**Re: Application for Site Plan Control 60 Pond Street
Norfolk County
File: 150**

60 Pond Street Third Submission Comments Matrix Responses

SCALE	1:300 METRIC	PROJECT NO.	7222
DRAWN BY	R MORRISON	DWG. NO.	SP1
CHECKED BY	N.B.	REV. NO.	5
DATE	NOV 2024		
FILE NAME	7222

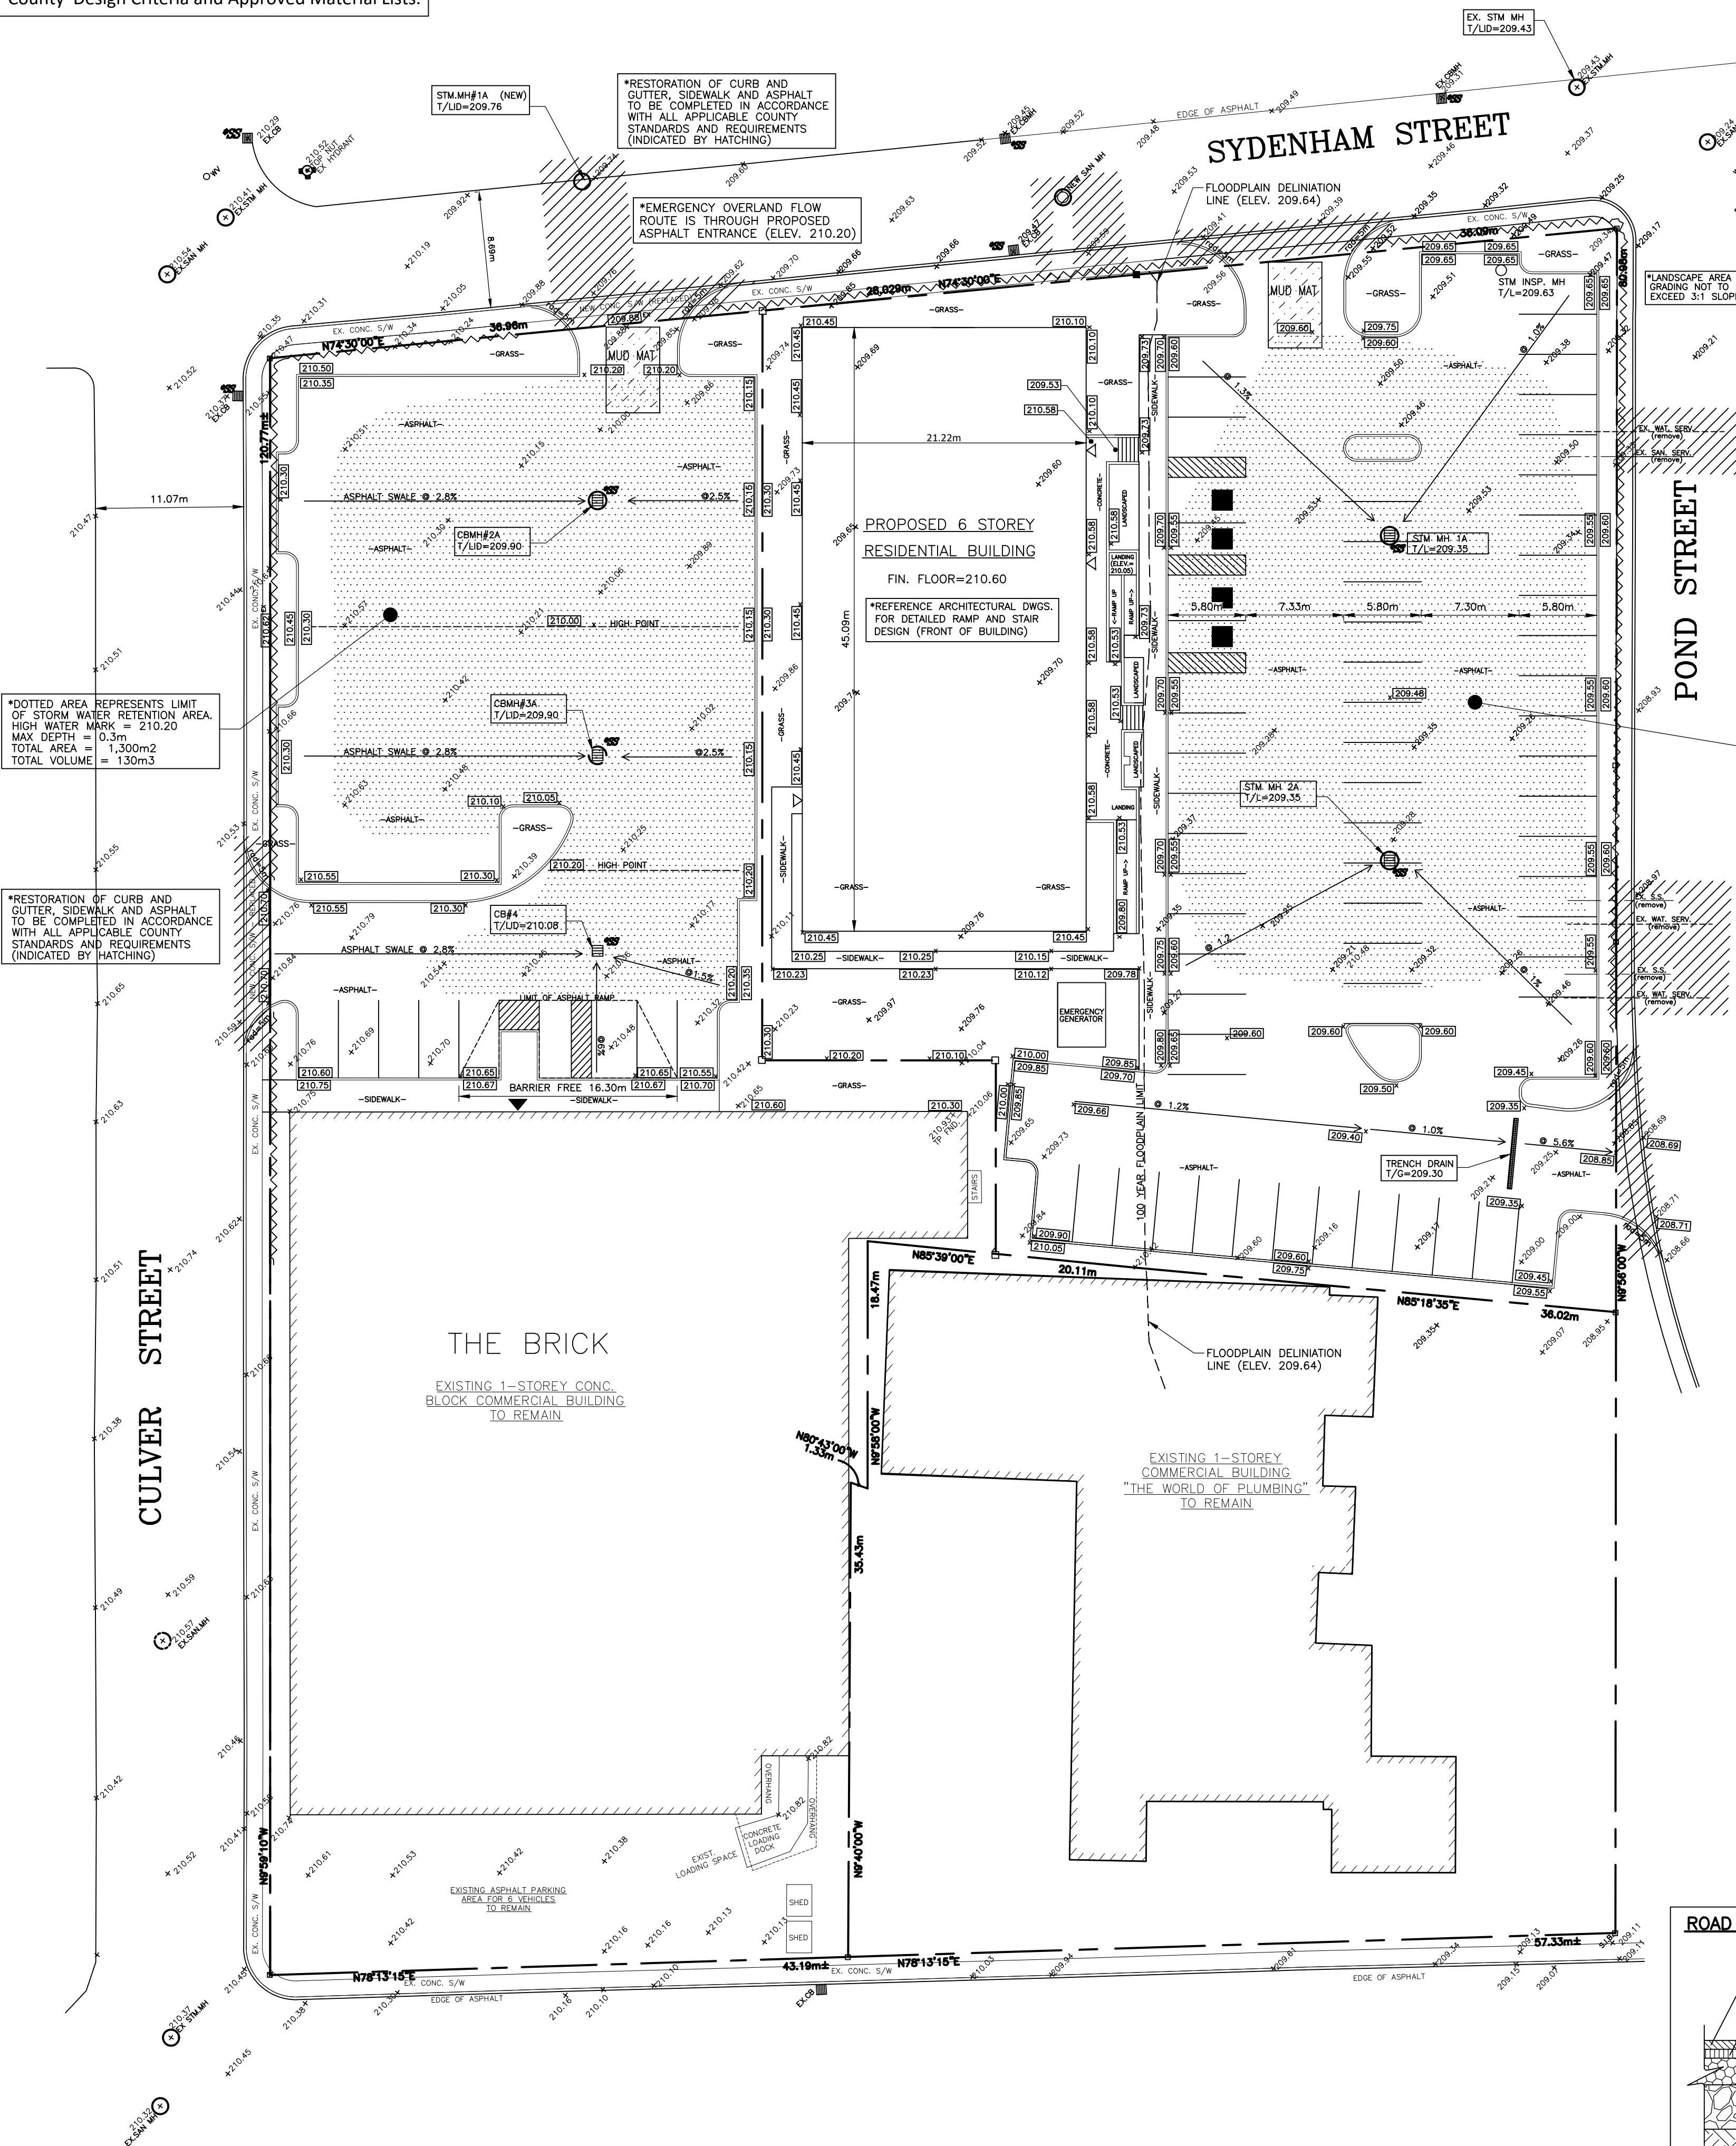
2) The detailed grading plan needs to remove any reference to GRCA, it is noted in a comment box on drawing SP1 Rev. No.2. Also, the vertical datum needs to be added to the drawing.	References to GRCA have been removed. Vertical Datum has been identified on Grading Plan (General note 15)	MC Engineering

3) The floodplain delineation map needs to remove any reference to GRCA and the vertical datum needs to be added to the drawing.	References to GRCA have been removed. Vertical Datum has been identified on Grading Plan, (dwg. SP1, general note 15)	MC Engineering
Conditions for Site plan To be Satisfied Prior to Site Plan Agreement:	Detailed Grading Plan including existing and proposed	MC Engineering

SCALE 1:500 METRIC	PROJECT NO. 7222
DRAWN BY R MORRISON	DWG. NO. SP2
CHECKED BY N.B.	REV. NO. 5
DATE NOV 2024	
FILE NAME 7222

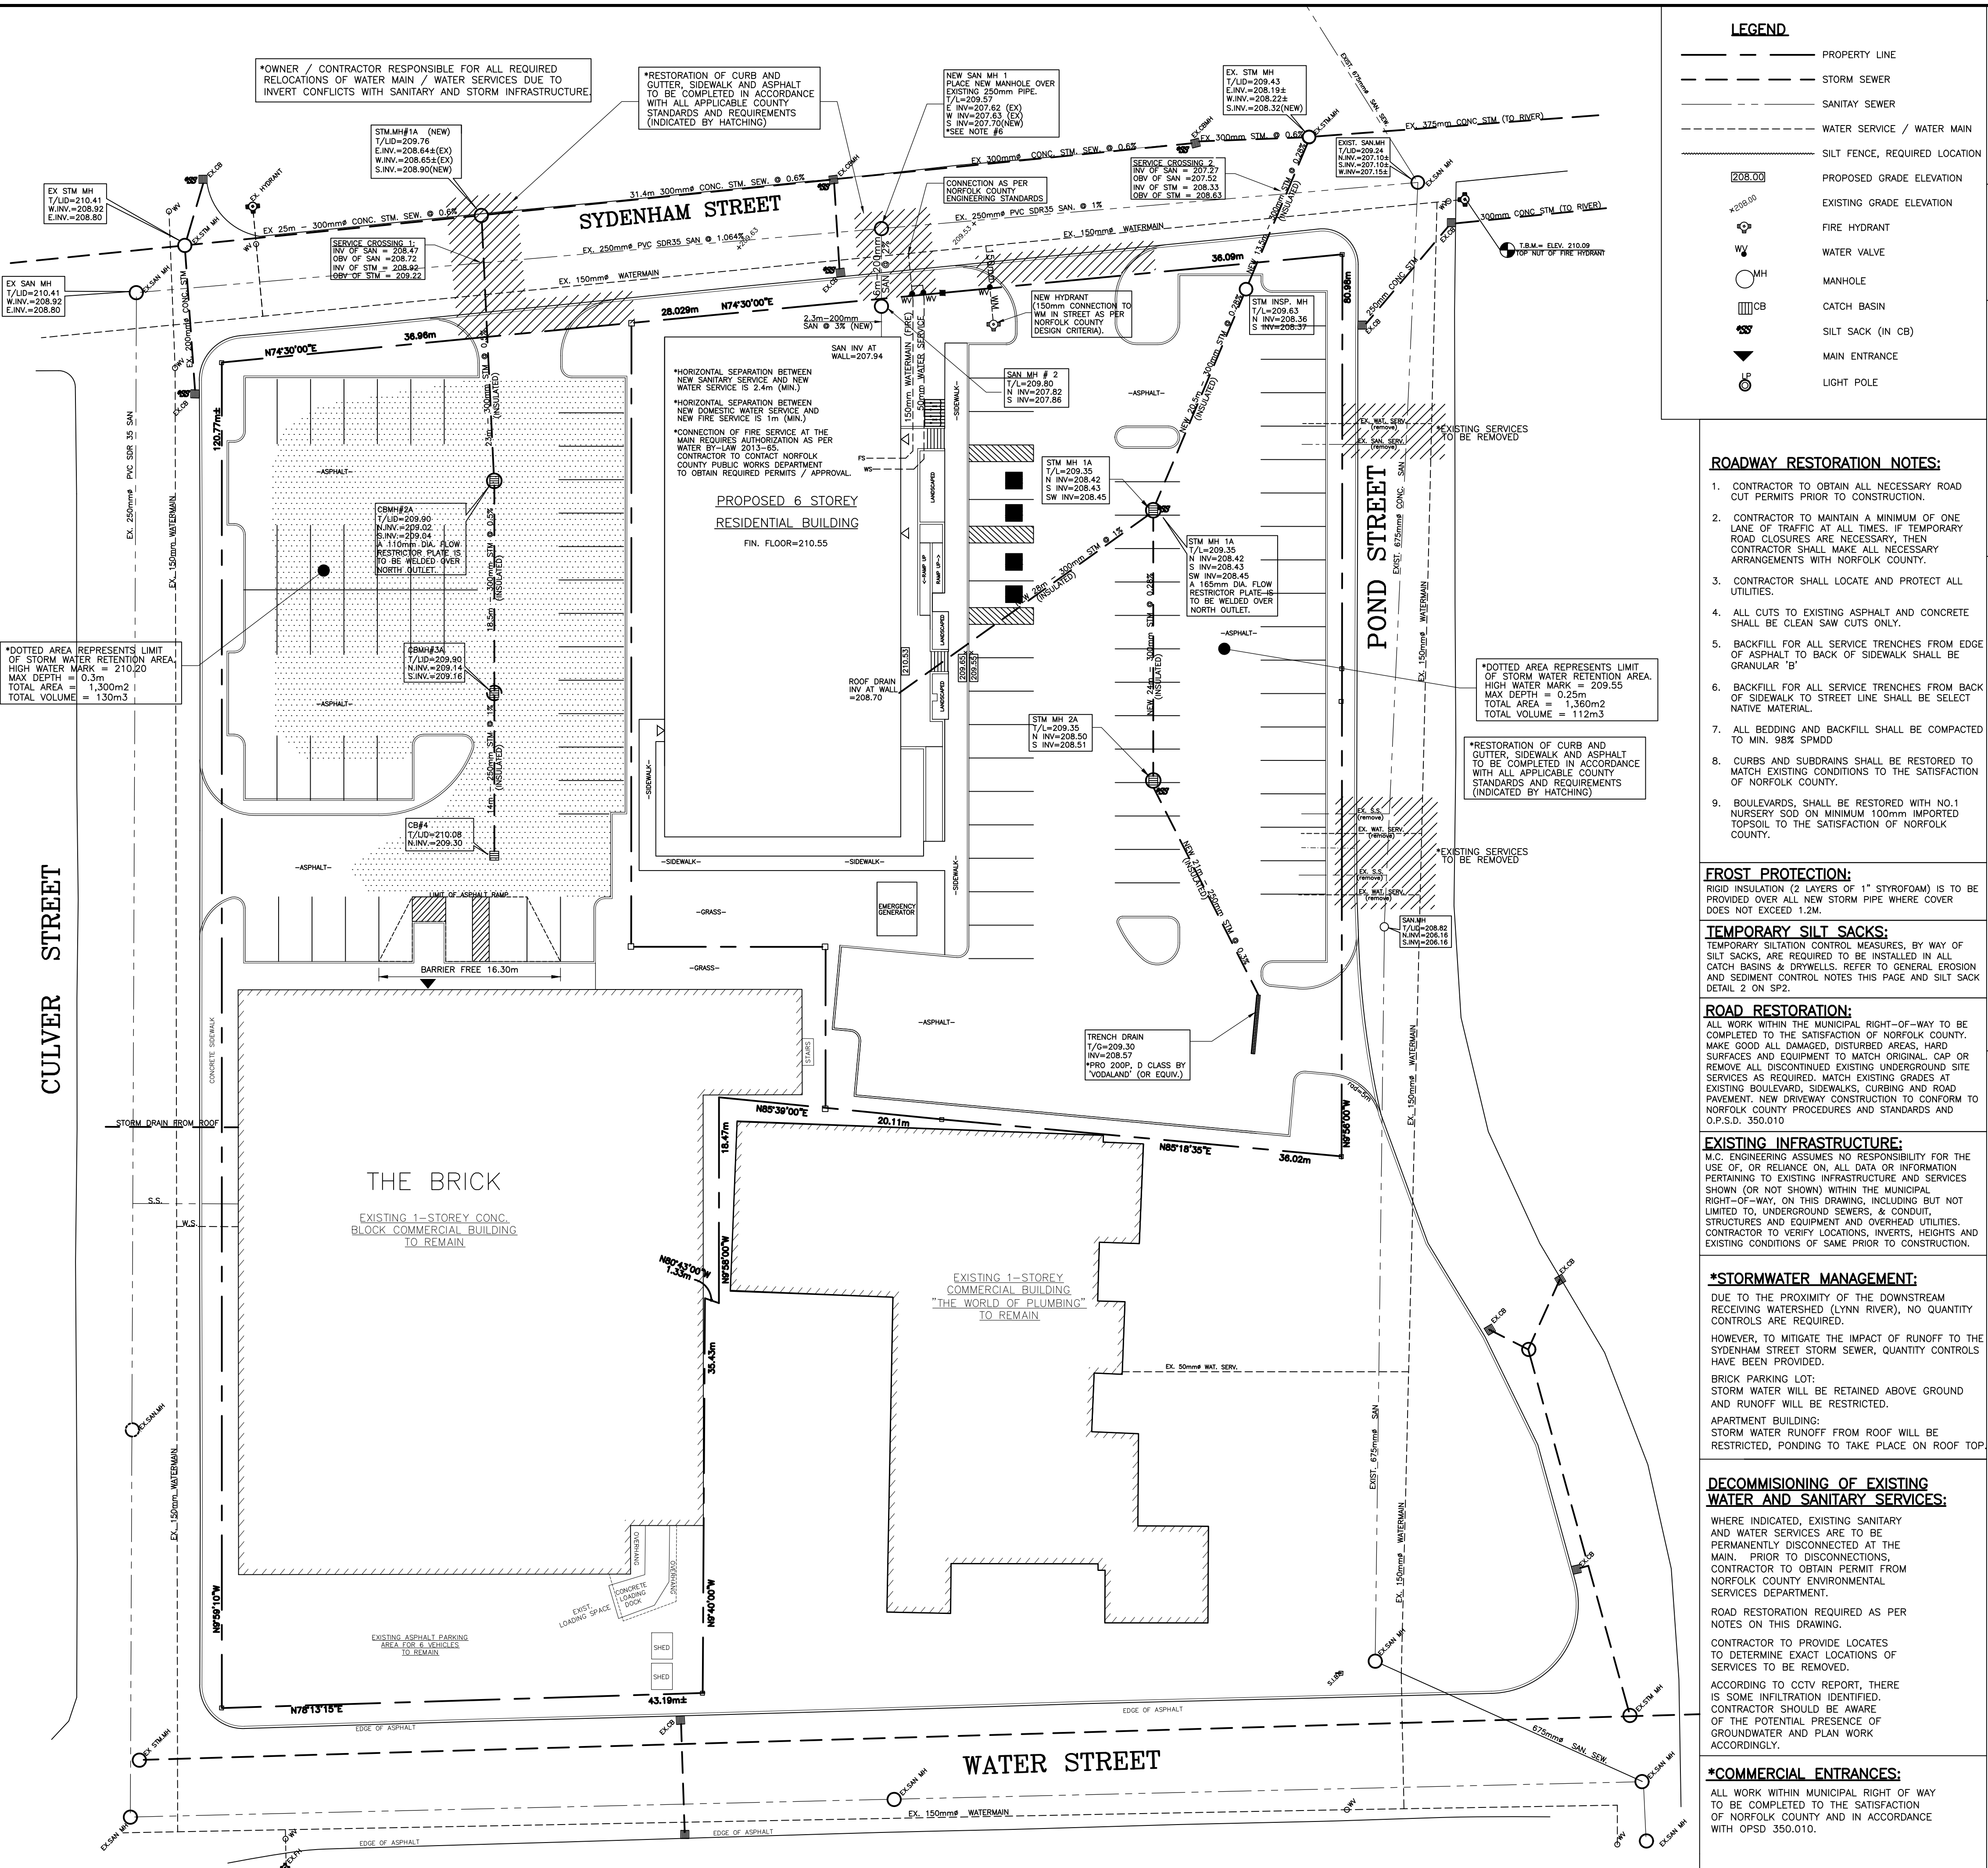
23.Not addressed from 1st submission - The separation distance between the 200mm SAN Service and the 150 mm Fire Service has to be labelled on the drawing. The 1.0 m separation distance for the fire	Separation requirements are no listed on SP2 (noted on building near servicing location)	MC Engineering

Figure 9B: Sight Line Analysis – Pond Street Access

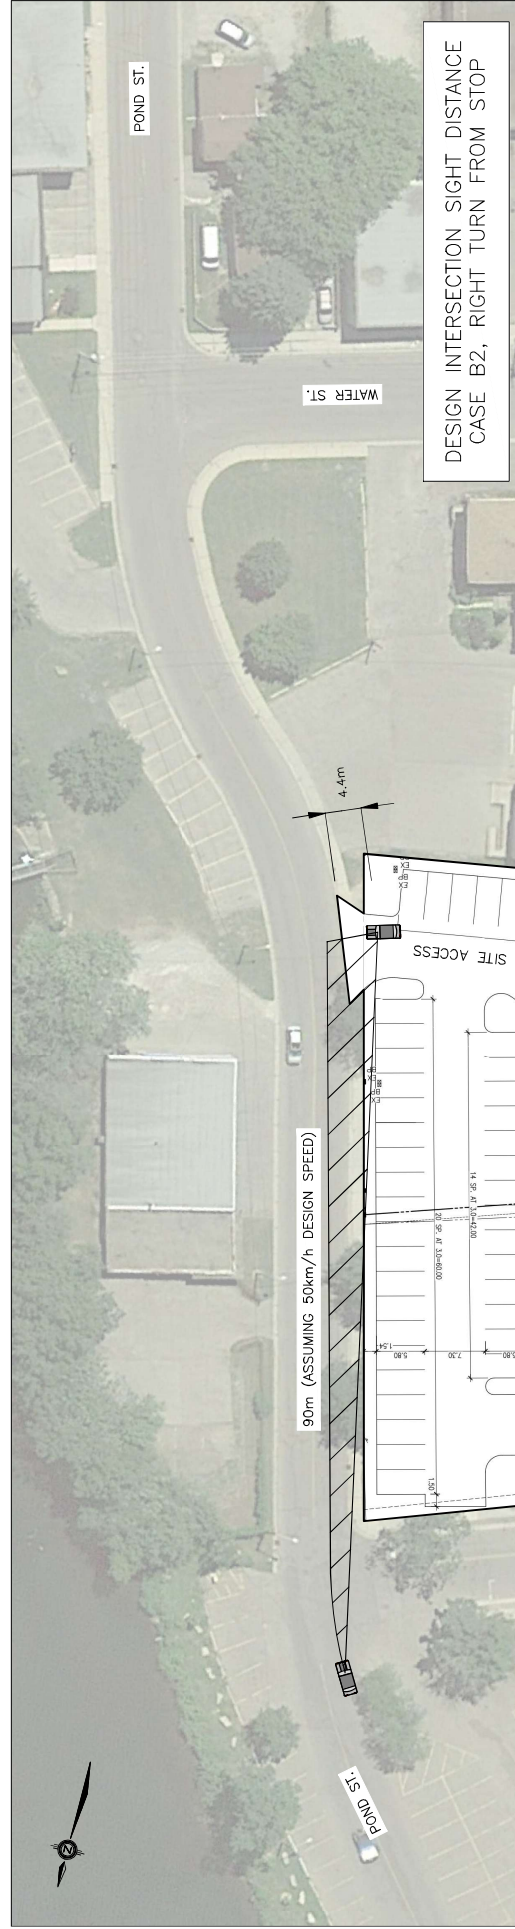
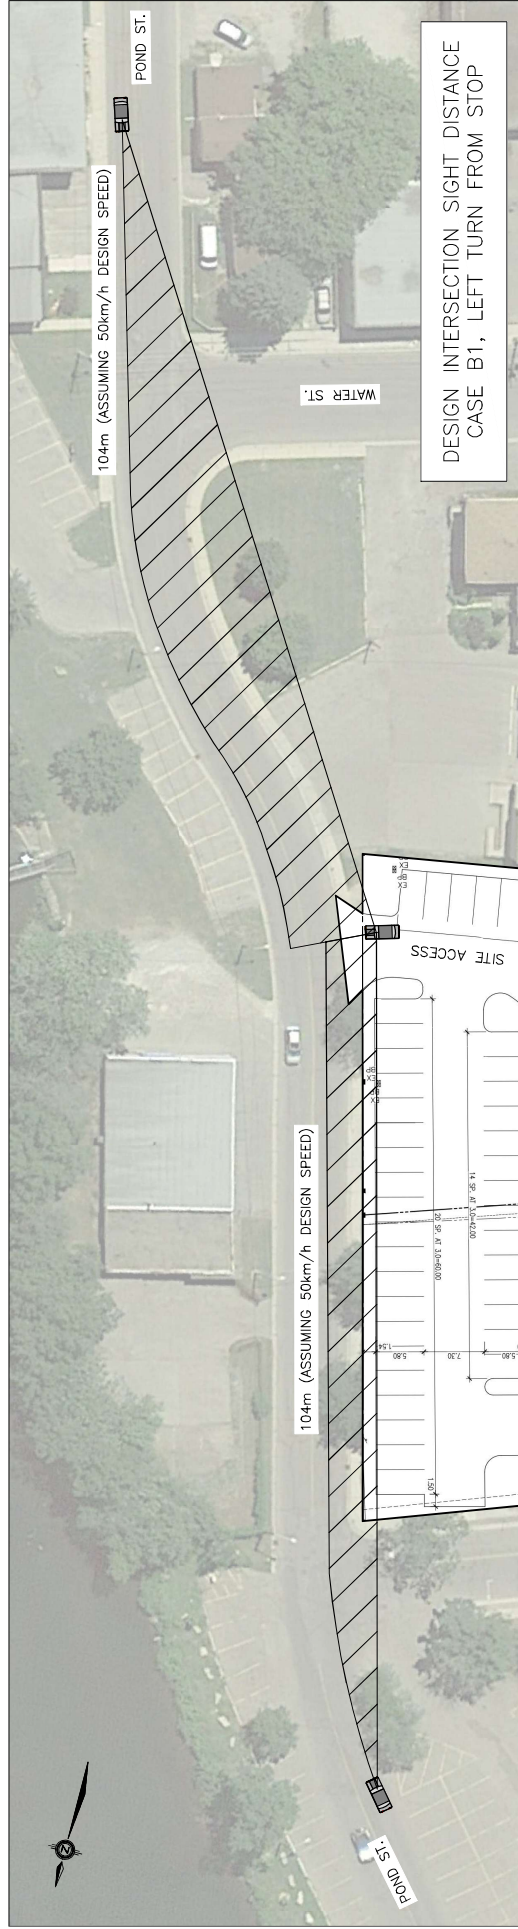
and tree preservation plan ii. Also, Figure No. 9B shows that the site distance for the proposed Pond Street egress, left turn from stop is impacted by existing trees located south of the site at the intersection of Pond Street and Water Street. It is anticipated that these trees will remain on the neighboring site and the report is to include commentary on their impact if they are to remain, as well as recommendations for any mitigation or movements restrictions to/from the site NOTE: This was a comment from 1st submission and with No response matrix Norfolk County cannot confirm if the Engineer has acknowledged the comment nor can we confirm how the concerns in the TIS are being managed through the design. Please provide a detailed response in the Matrix in your next submission. Confirm if the trees are being removed. How will sight lines be met.		
--	--	--
